APPLICATION NO: 13/00756/FUL		OFFICER: Mrs Wendy Hopkins	
DATE REGISTERED: 10th May 2013		DATE OF EXPIRY : 9th August 2013	
WARD: Leckhampton		PARISH: LECKH	
APPLICANT:	Martin Scott Homes		
LOCATION:	Leckhampton Industrial Estate, Leckhampton Road, Cheltenham		
PROPOSAL:	Demolition of existing buildings and residential development comprising the construction of 28 dwellings

REPRESENTATIONS

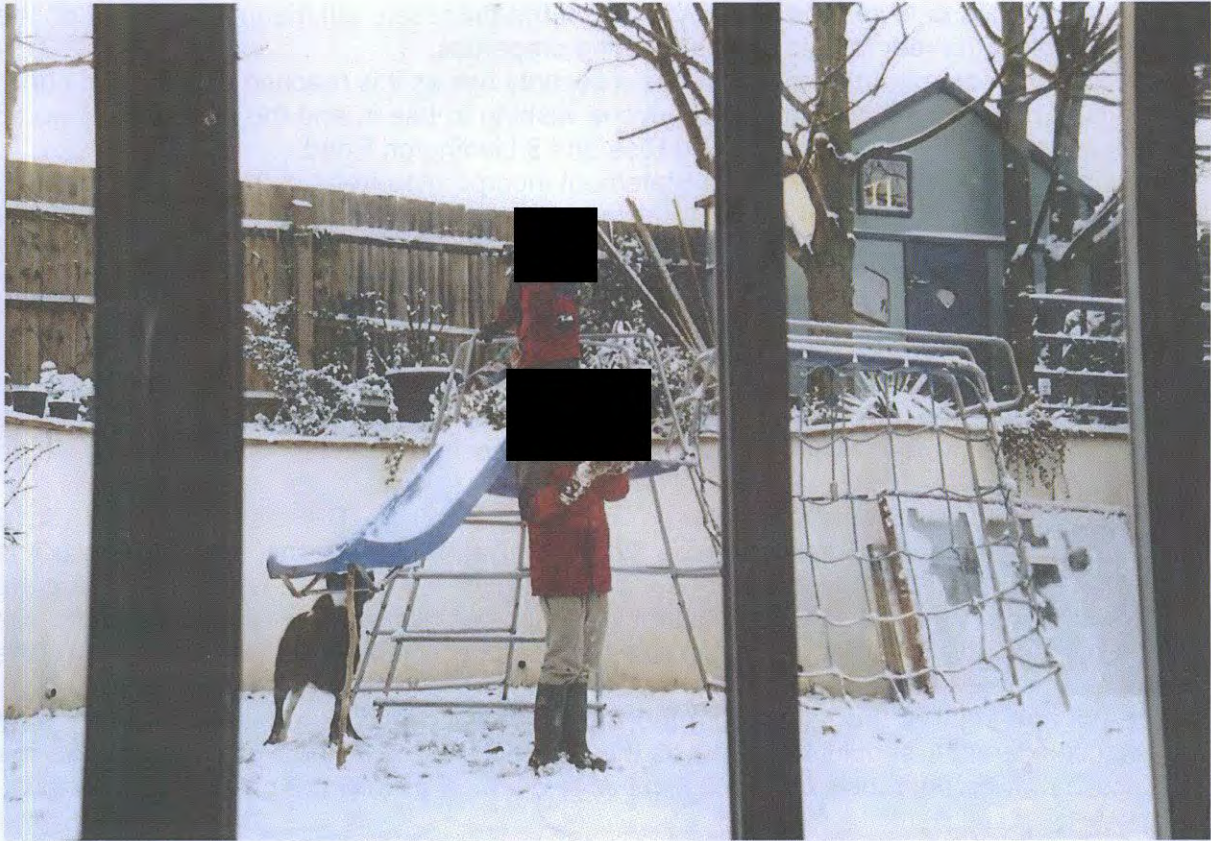
- f. The Planning Statement notes 'secure cycle spaces and bin locations are provided within each property's curtilage'. The Design and Access Statement does not mention Bicycles and states 'all houses have external access to rear gardens. Refuse bins will be located within rear gardens'. These statements do not appear considered in relation to the site plan and

proposed changes of level. The likely outcome of the proposals will mean bins stored on the street or against the rear fences of neighbouring properties.
